Appeal NO: ABP 322098

20250411-ABP-322098

Ref: 322098

For: The development of an Anaerobic Digestion (AD) Facility to produce a renewable biomethane gas for direct injection into the national gas grid on a site of circa 7.28 hectares at the townland of Collinstown, Lusk, Co Dublin. The development comprises of AD tanks and processing equipment, feedstock storage facilities and equipment, silage storage clamps, digestate management and storage facilities. Carbon dioxide from the production of this biomethane will be captured for reuse in the Irish food industry.

Graph from Bakkaloglu et al (2022)

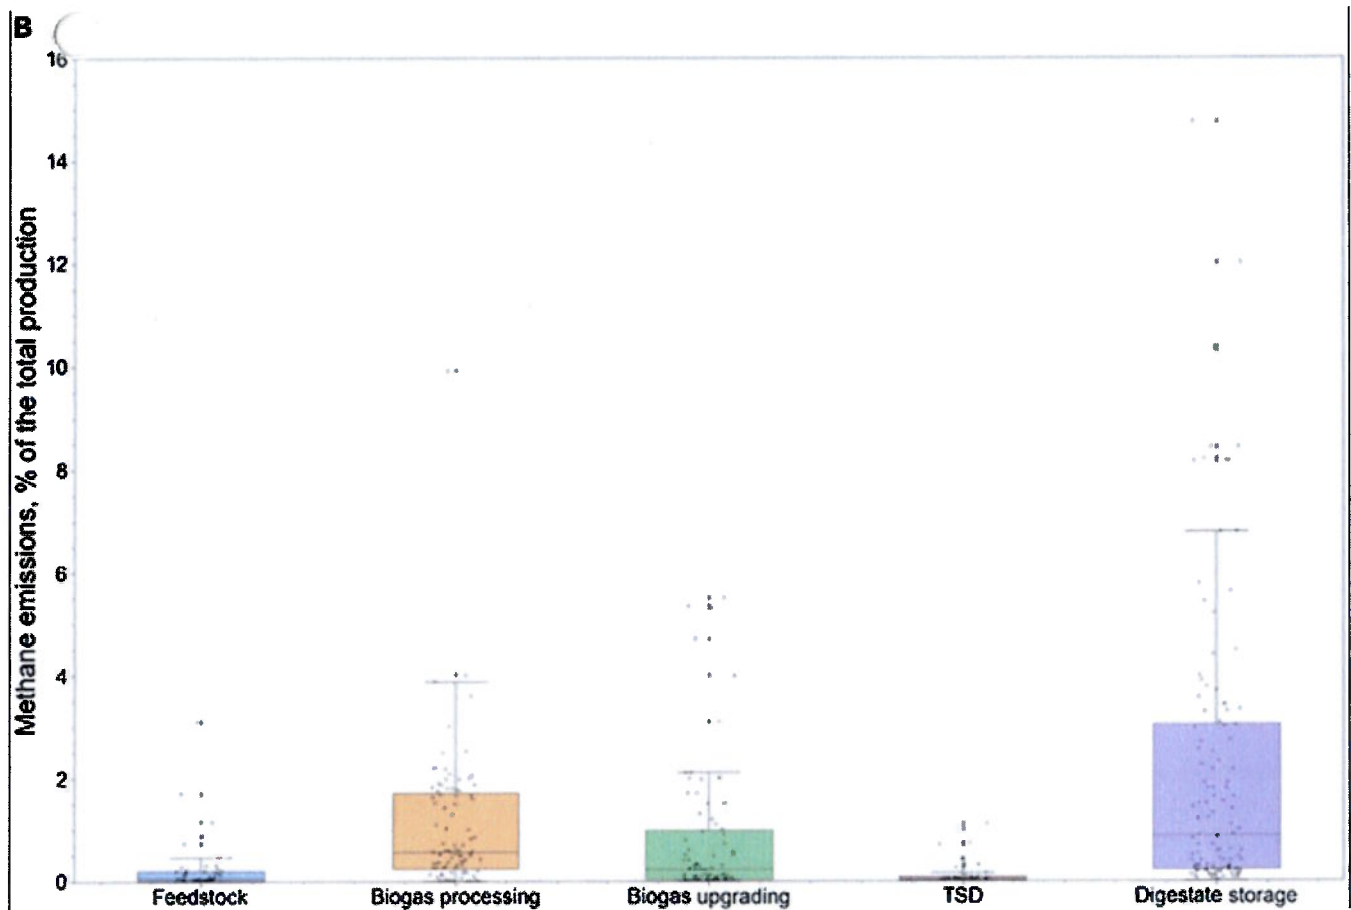
A study by Bakkaloglu *et al* (2022) highlights that methane losses in the biomethane and biogas supply chain exceed those in oil and natural gas and must be mitigated against to adhere to climate obligation and limit global heating, *"Methane emissions could be more than double what has been previously estimated, according to the aforementioned study, with the digestate stage responsible for the majority of methane released. To realise the climate benefits of biomethane and biogas production, effective methane-mitigation strategies must be designed and deployed at each supply chain stage."* The graph below illustrates the proportion of each stage of the biomethane production process which contributes to methane emissions.
